## REQUEST FOR BOARD ACTION

### HENDERSON COUNTY PLANNING BOARD

**SUBJECT:** Revised Master and Phase III Development Plan Couch Mountain (Formerly Luna Ridge) Major Subdivision (2019-M03)

**Combined Revised Master and Phase III Development Plan  
Couch Mountain Major Residential Subdivision (2019-M03)**

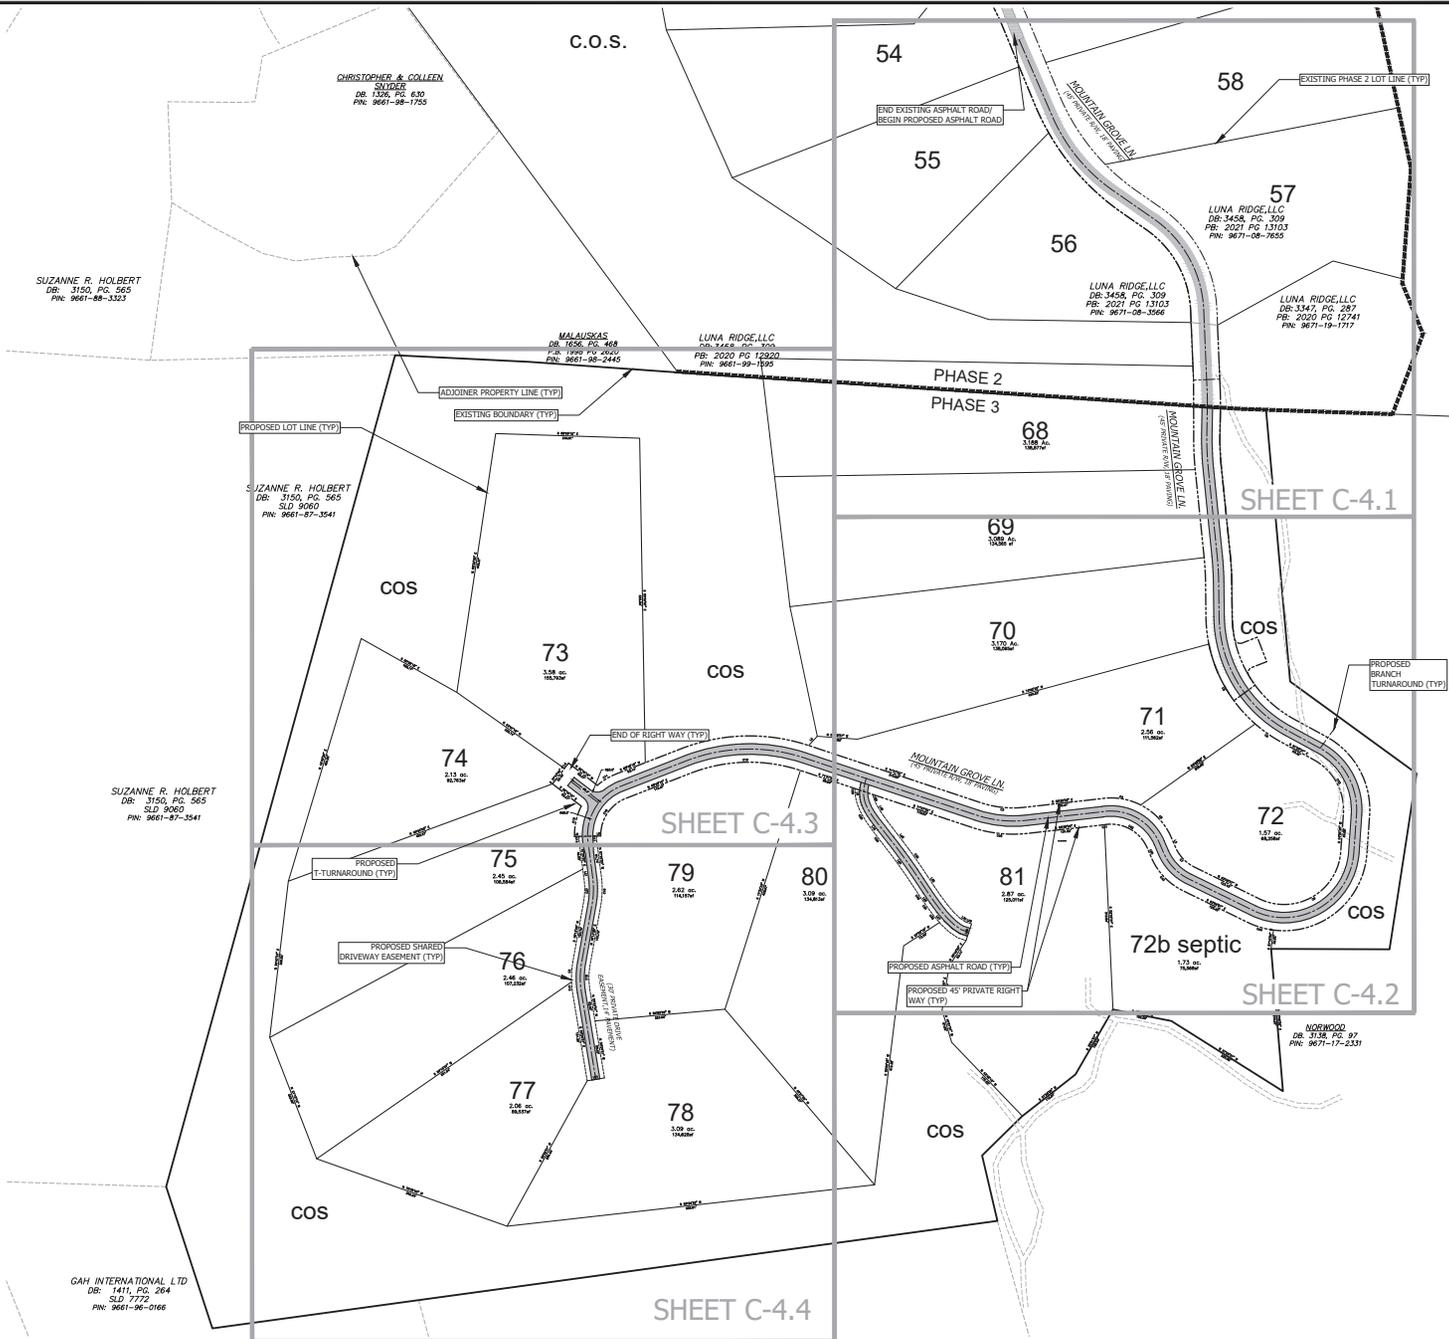
1. **Soil Erosion and Sedimentation Control Plan.** The Applicant shall submit written notice from the appropriate local agencies verifying that an Erosion and Sedimentation Control Plan has been received or a written notice from a professional land surveyor, engineer, landscape architect, architect, or professional planner certifying that no plan is required (LDC §42-95B).

2. **Water Quality.** The Applicant shall submit written notice from the appropriate local agencies verifying that a Stormwater Management Permit has been received (LDC §42-95E).

3. **Private Roads.** Private roads shall be constructed in accordance with the Private Subdivision Local Road standards stated in Chapter 42 (LDC§42-109). Additionally, subdivisions of 35 or more lots shall provide a minimum of two entrance roads. The second entrance road may be specifically waived by the approving authority where unique circumstances exist (LDC §42-95A (1)).

5. **Road Drainage, Culverts and Shoulder Stabilization.** Road or drainage structures shall be constructed in accordance with state roads standards. Road drainage side ditches shall be constructed with sufficient depth and width to carry the expected volume of storm water runoff (LDC §42-100). All areas disturbed by the construction of a public road, including cut and fill

6. **Road Name Approval.** Proposed road names for a private and/or public road shall be preapproved by Henderson County in accordance with Chapter 42 of the Henderson County Code, Property Addressing (LDC §42-103). The names of the proposed roads and easements should be confirmed with the development plan approval.

8. **Street Tree Requirements.** According to the street tree requirements of Chapter 42 (LDC §42-95H) the applicant must provide one tree per 50 linear feet of property abutting an internal road. Trees may be placed in groups with a minimum spacing of no less than 15 feet and a maximum spacing of no more than 65 feet. The trees may be placed within the right-of-way or within 20 feet of the edge of the right-of-way. The applicant may use existing trees in accordance with LDC §42-185 instead of planting new trees. These existing trees must also be located within the right-of-way or 20 feet off the edge of the right-of-way as required by LDC §42-185.

9. **Perennial and Intermittent Surface Water Buffer.** All built-upon area shall be a minimum of 30 feet landward of all perennial and intermittent surface water, as defined in LDC §42-251.
